UNITED STATES PATENT AND TRADEMARK OFFICE

Office Action Summary	Application No. 10/593,517	Applicant(s) FREEMAN, ALAN JOHN MORRIS	
	Examiner ALEXANDER B. COMLEY	Art Unit 3746

DETAILED ACTION

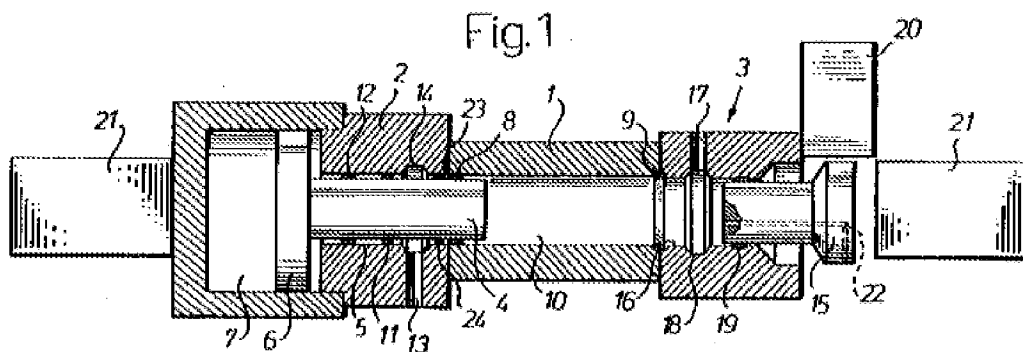
8. **Claims 1-9 and 11-22** are rejected under 35 U.S.C. 102(b) as being anticipated by United States Patent No. 5,579,682 to Bergman et al.

In regards to Independent **Claims 1 and 11**, and with particular reference to Figure 1 shown immediately above, Bergman discloses a pressure intensifier assembly for pressurizing foodstuffs such as tomato sauces, fruit-based pulps, and quenelles (See Col. 1, Lines 20-25). Bergman's device utilizes a cylinder-and-piston 1, 4 (i.e. barrel assembly), pressurizing means (4-7), end closure assemblies (2, 3), and a surrounding tension frame with clamping pistons 21 (See Col. 6, Lines 17-36) Just like

Applicant's tension frame and clamping pistons, the tension frame/pistons 21 of Bergman are designed to press against the end closures (2, 3) in order to take up any axial forces placed thereon during pressurization inside chamber 10 (See Col. 7, Lines 4-17) Bergman's intensifier also appears to operate in the same manner as Applicant's invention (See Col. 7, Line 52 – Col. 8, Line 34)

6. In regards to dependent **Claims 2 and 12-14**, the tension frame/pistons 21 take the form of a clamping yoke. Regarding dependent **Claims 3 & 15**, first and second seal assemblies (8, 9) are disposed on either end of the high pressure barrel 1. In regards to dependent **Claims 4 & 16-17**, the pressurizing means (4-7) is a hydraulic piston/ram assembly (See Col. 8, Lines 3-10) Regarding dependent **Claims 5 & 18**, the surrounding housing of Bergman's intensifier acts as a stand. In regards to dependent **Claims 6-7 & 19-20**, it can be seen in Figure 1 that no screws are utilized in retaining the various intensifier components together. Moreover, Bergman specifically states that his structure allows for quick disassembly thereof (See Col. 5, Lines 49-54) Hence, the barrel 1 can be opened rapidly, and therefore allows for quick detachability thereof. Regarding dependent **Claims 8 & 21**, it can be seen in Figure 1 that the right end closure 3 is retractable via its plunger member 15 when the press frame pistons 21 retract therefrom (See Col. 8, Lines 27-34) And finally, in regards to dependent **Claims 9 & 22**, it is clear that the pressurizing fluid lifts the piston 4 of the barrel assembly during pressurization.

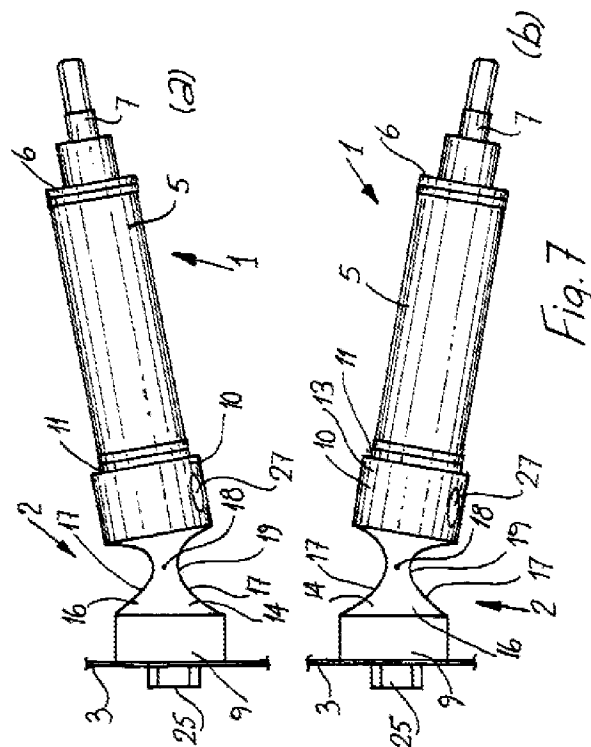
9. **Claims 10 and 23** are rejected under 35 U.S.C. 103(a) as being unpatentable over United States Patent No. 5,579,682 to Bergman et al. in view of United States Patent No. 5,904,089 to Jansson et al.

With reference to Figure 7 pictured above, Jansson discloses the use of a hinged pivot mechanism (14-19) for allowing a ram mechanism to pivot on its base (See Col. 5, line 60 - Col. 6, Line 28) Both Bergman and Jansson are aimed at providing better ram apparatuses. Therefore, to one of ordinary skill desiring a more versatile ram, it would have been obvious to utilize the pivoting techniques disclosed in Jansson in combination with Bergmann in order to obtain a predictable result; that result being a pivoting ram housing that allows for better access thereto.
